An Exploration of Deficiencies Within the Proposer's Environmental Statement on Noise and Vibration

This is a written representation submitted to the Planning Inspectorate as part of the examination of the Hinckley National Rail Freight Interchange (HNRFI) submitted by Tritax Symmetry (Hinckley) Limited. This document contains an exploration of deficiencies within the proposer's Chapter 10 on Noise and Vibration, particularly the [Main Statement, document reference: 6.1.10 \("the report"\)](#).

NMP4 - Time History Graph

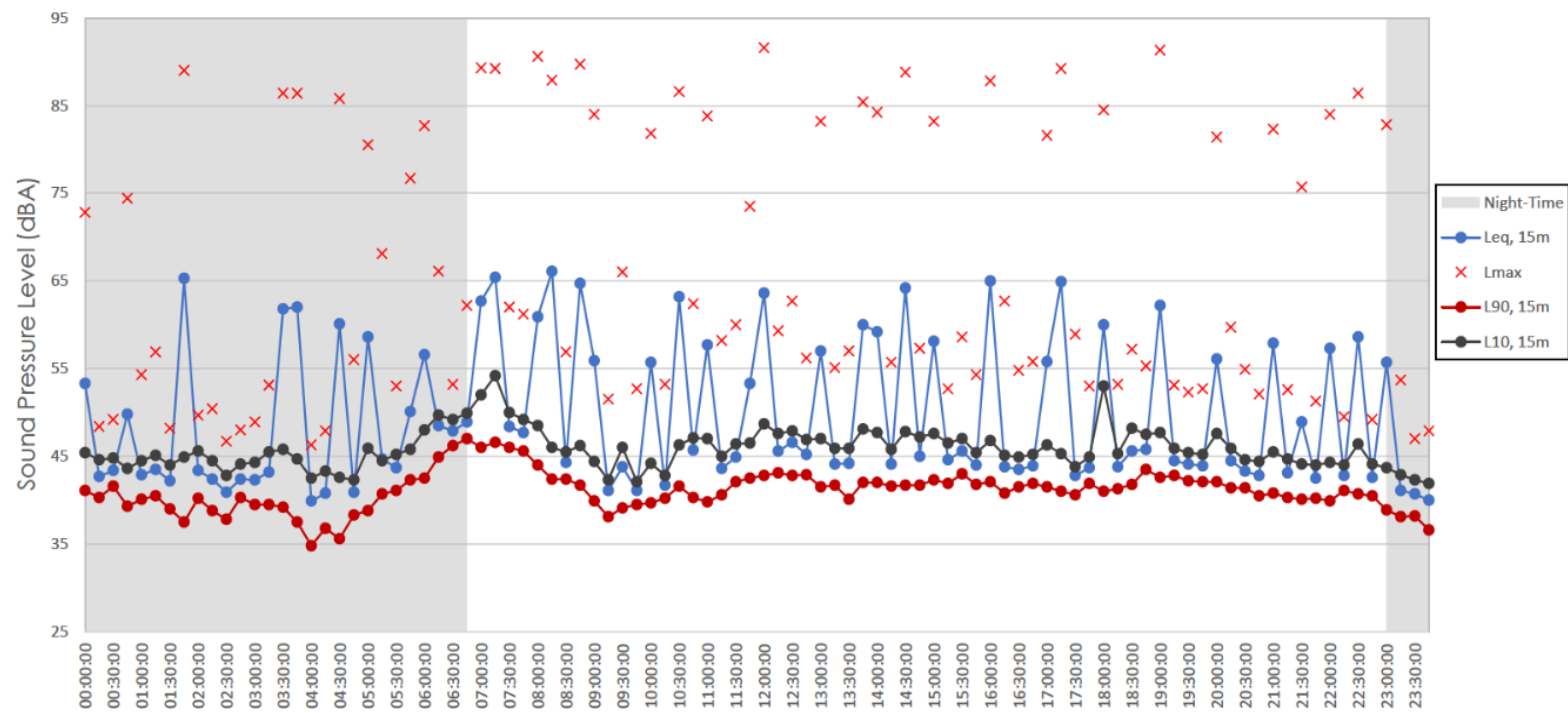
Unsurprisingly, measuring sound levels in extremely close proximity to a railway line led to significant spikes in Leq values as trains passed by. The impact on NMP4’s stated Leq values can be seen in full within [Appendix 6.2.10.10 Summary Results](#). An example of results over a 24 hour period is included below.

The report has then taken the LAeq levels derived from measurements at NMP4 and stated that they are representative of LAeq levels at receptors located as far as ~450 metres from the railway line. The median distance between each relevant NSR and each NSR's closest point on the railway line is ~333 metres.

No attenuation corrections have been applied to the sound of train pass bys to account for the distance between each receptor location (NSRs 1-8 & 24-26) and the railway line, because the report considers the monitoring position to be representative of the receptor locations. The LAeq values derived from measurements at NMP4 have been taken and attributed to NSRs 1-8 & 24-26 on weekdays and weekends, day and night. All eleven have been given the same values, as can be seen in Table 10.43 & Table 10.44. In the view of the report, that is entirely reasonable and requires no comment or justification. The report states the weekday ambient sound levels at the NSRs are 59.2 dB in the weekday daytime and 56.2 dB in the weekday night-time.

BS4142:2014+A1:2019 has been flouted because the results derived from NMP4 have not been made representative of the receptor locations through the application of attenuation corrections to the sound of train pass bys to account for the distance between the railway line and each receptor. The report states the receptors' current sound levels as if they were located at the railway line, as NMP4 was.

Hinckley Rail Interchange
NMP3 - Time History Graph
00:00 on 26/04/2021 to 00:00 on 27/04/2021

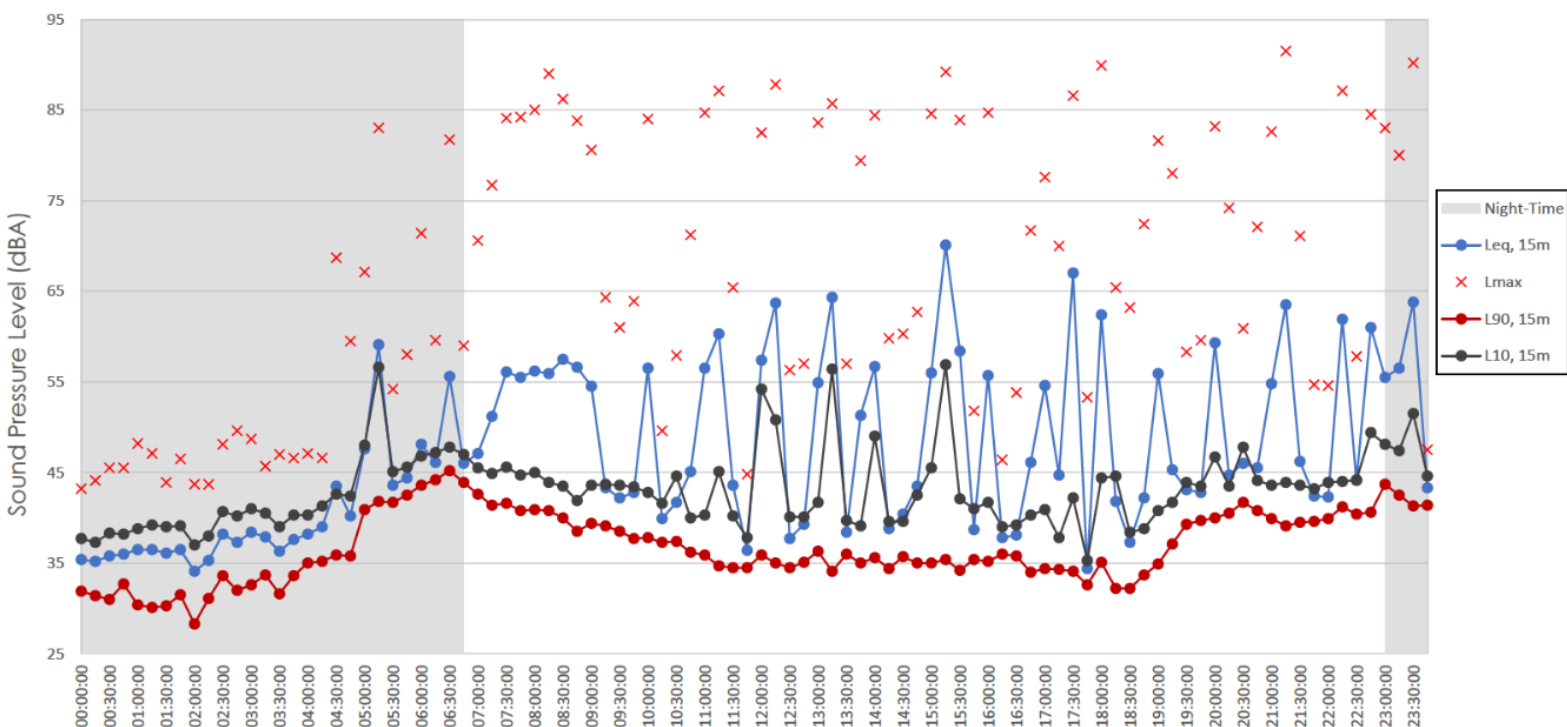
Unsurprisingly, measuring sound levels in extremely close proximity to a railway line led to significant spikes in Leq values as trains passed by. The impact on NMP3's stated Leq values can be seen in full within [Appendix 6.2.10.10 Summary Results](#). An example of results over a twenty-four hour period is included below.

Lack of Attenuation Corrections at Burbage Common & Woods

The report compares predicted operational noise levels during the daytime at NSR 19, the location chosen to represent Burbage Common & Woods, with the stated background at NSR 19. This leads to levels 19 dB above background during the weekday daytime and 17 dB during the weekend daytime, as shown in Table 10.39 & Table 10.41. The report goes through its routine of having background levels supplanted by stated ambient sound levels.
